**Index 102-600 and Specification 102**  
**General Information for Traffic Control Through Work Zones**

**ORIGINATION****Date:** 7/20/2022**Name:** James McGinnis**Phone:** (850) 414-4952**Email:** James.McGinnis@dot.state.fl.us**COMMENTARY**

**COMMENTS AND RESPONSES**

## 2. Sheet 4 of 11:

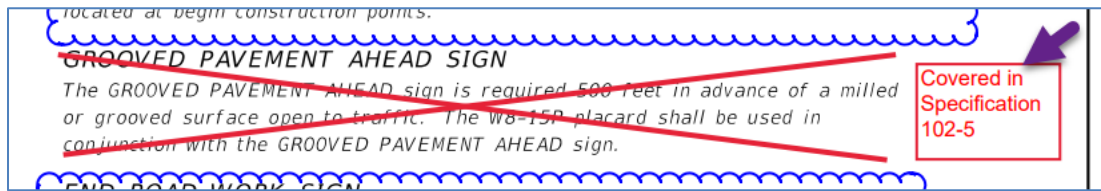
The information for the signing ahead of grooved or milled pavement is not in the specifications 102-5.

**RESPONSE:** This language is being added to Specification 102-5.3 (Maintenance of Roadway Surface). Please refer to draft *Specification 102* revisions.

## 3. Sheet 10 of 11,

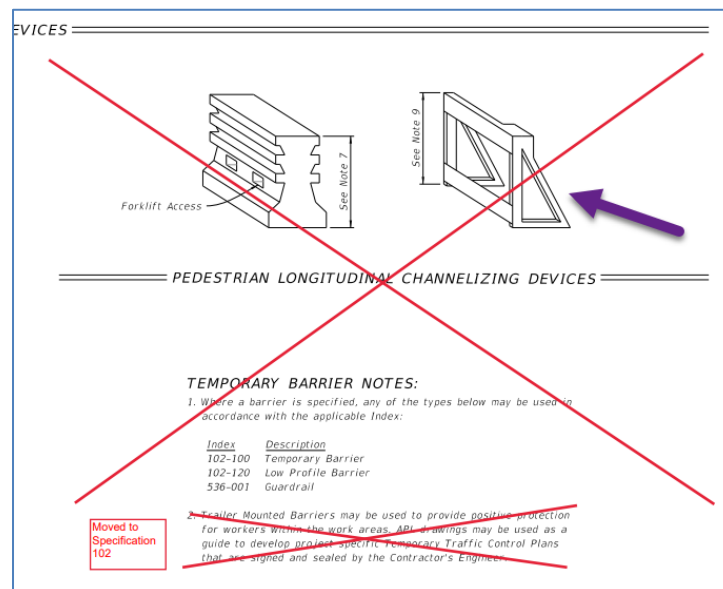
This diagram does not serve a purpose at this time because it does not have any measurements. However, instead of deleting this, it should be better to keep them and add dimensions. The other barriers are in the index with dimensions.

**RESPONSE:** The details were removed because the LCD dimensional requirements now prescribed in *Specification 990* and are requirements for the devices to be listed on the APL. Referencing the APL would be a better source of information. No LCD looks like the illustration on the left and many others are not consistent with the illustration on the right. For these reasons they were removed. For the other devices shown on the Sheet 10, the dimensions are used define products acceptance on the APL and the details consistently depict those devices.

**SPEED REDUCTION SIGNING**

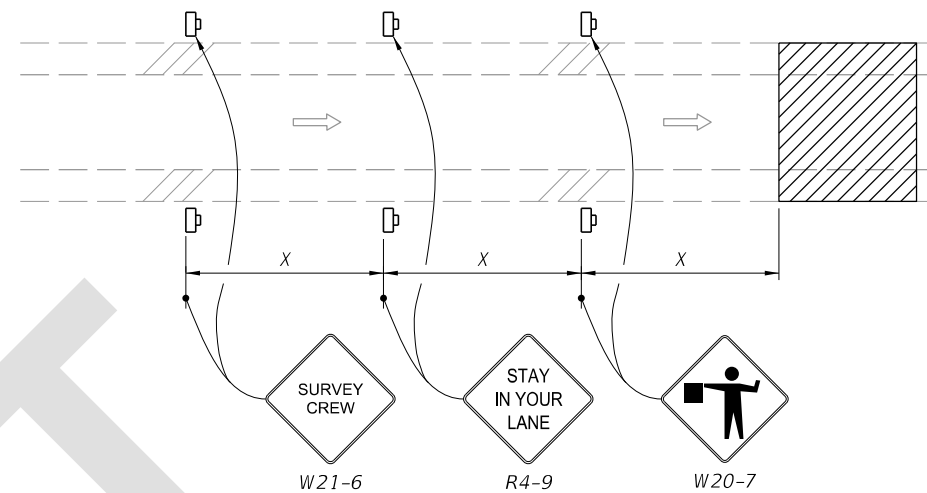
**COMMENT:** Current Sheet 3 of 11: if an additional speed limit sign instructing drivers to get back up to speed is being added it seems unnecessary considering Contractor’s will have to identify locations of existing speed limit signs outside of work zones. A Contractor could be held liable if a sign, outside of the work zone, is hit/damaged requiring this added speed limit sign to be installed, without knowledge, because the distance to the next speed limit sign is more than 1,000 feet. Also, there could be confusion if a speed limit at the beginning of the project is different than the speed limit sign through the project or after the project. A regulatory sign that says END REDUCED SPEED would be a better option.

**COMMENT:** Please consider the following suggestion regarding Work Zone Speed Reduction signing: On Sheet 3 of Index 102-600, add a G20-5aP WORK ZONE plaque above the SPEED LIMIT sign to emphasize that a reduced speed limit is in effect within a TTC zone. Please refer to MUTCD Sec. 6F.12

**RESPONSE:** Returning traffic to the original posted speed after the work zone is an existing FDOT Policy. If a sign is not added, the regulatory speed will be the ‘work zone speed’ until the next ‘existing speed limit’ sign is reached. The addition of sign will reestablish the existing posted speed limit in locations where the next speed limit sign may be a considerable distance from the work area. Contractors are not liable for signs outside the project limits. The proposed sign was reviewed, and its agreed that a “End Work Zone Speed Limit” would also be acceptable.

**Change made to Index:** Changed SPEED LIMIT sign (R2-1) to END WORK ZONE SPEED LIMIT sign (R2-12). Changed Note 8 to have the SPEED LIMIT sign (R2-1) be optional instead of the END WORK ZONE SPEED LIMIT SIGN (R2-12).

**RESPONSE:** The Department has already standardized to the use of the W3-5, work zone speed reduction ahead message sign. The G20-5aP plaque may be added in accordance with the MUTCD at the option of the Designer, Engineer, or Contractor, but will not be standardized at this time.
